NUMBER: 09-003-15

Incorrect Bolt Length Used For Fastening Transmission To Engine

This bulletin involves replacing 2 bolts used to fasten the transmission to the engine.

Chrysler 200

Fig. 3 Two Bolts To Be Replaced

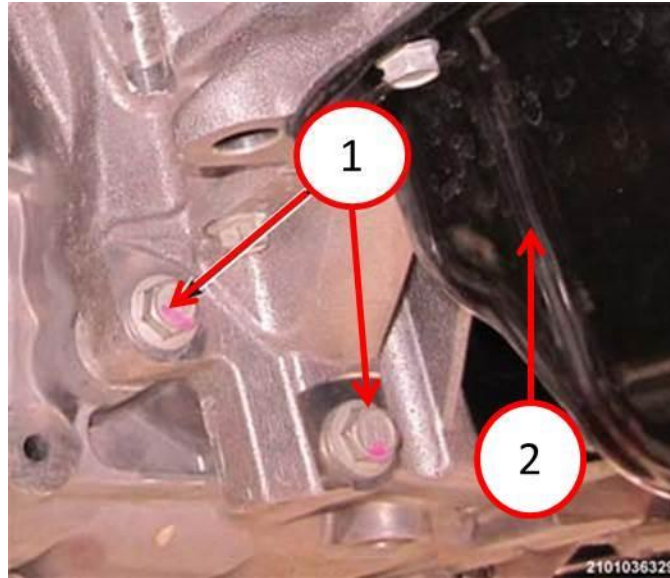
7. Remove and discard the 2 bolts (1) holding the engine block to the bell housing next to the differential housing, located directly below the starter at the front of the engine. (Fig. 3).
8. Install the new 45mm bolts in place of the bolts removed (Fig. 3). Tighten to 50 N·m (36 ft.lbs).
